**TOWN OF NEWBURGH
PLANNING BOARD
TECHNICAL REVIEW COMMENTS**

PROJECT NAME: AVION VENTURES-WAREHOUSE
PROJECT NO.: 24-16
PROJECT LOCATION: SECTION 86, BLOCK 1, LOT 37.222
REVIEW DATE: 14 FEBRUARY 2025
MEETING DATE: 20 FEBRUARY 2025
PROJECT REPRESENTATIVE: COLLIERS ENGINEERING AND DESIGN

UTILITIES PLAN

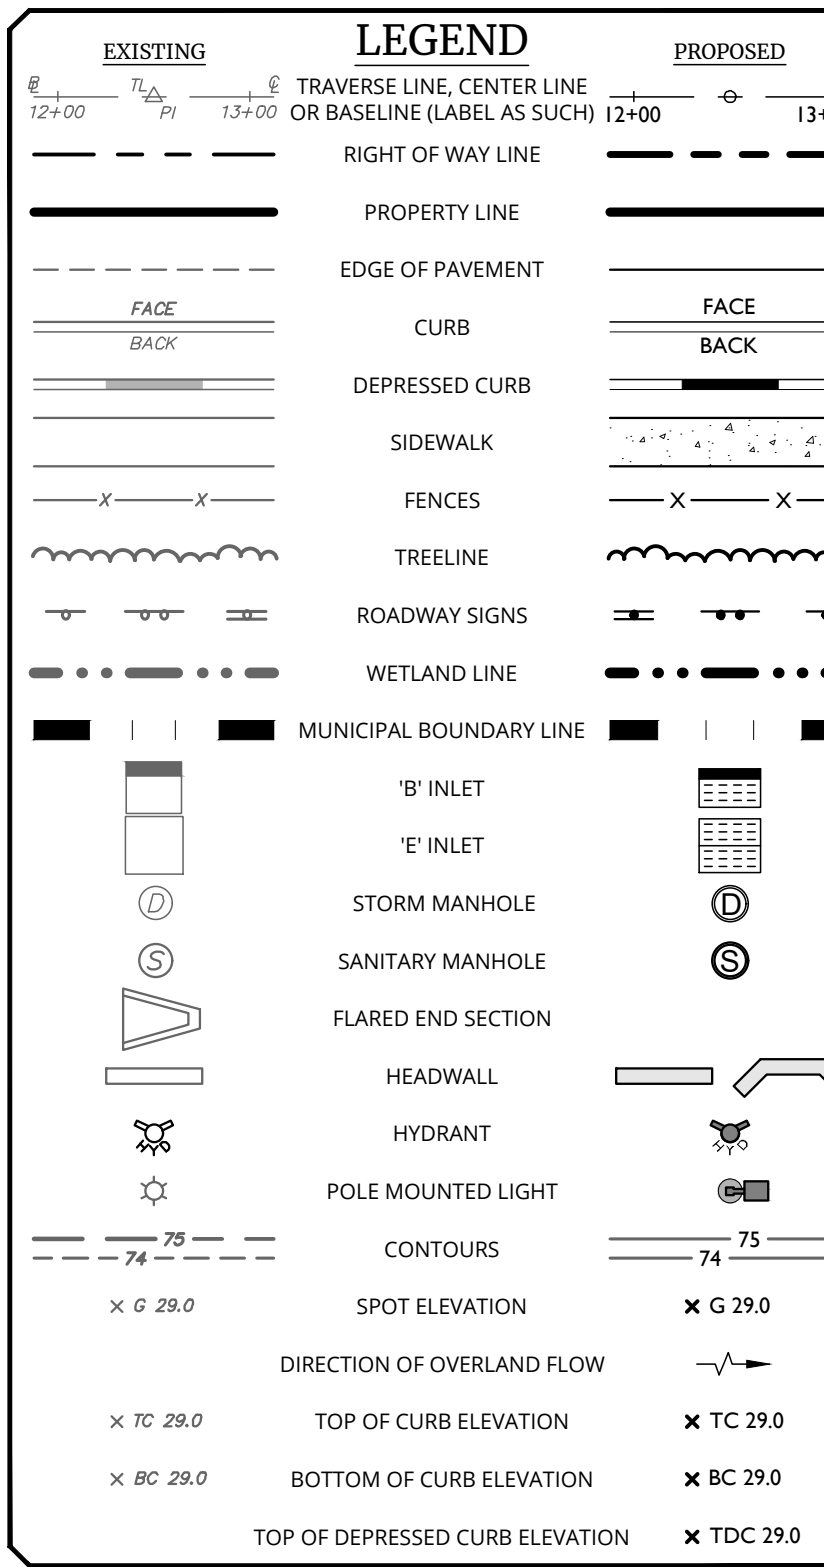
3. Show NYSDEC wetland buffer on the utility plans to clearly demarcate impacted areas.
4. A Preliminary SWPPP has been submitted and is under review by this office.

6. The utility plans identify a 3,000-gallon septic tank prior to the pump station. A grinder type pump station should be proposed in order not to discharge anaerobic septic effluent into the Town sewer system.
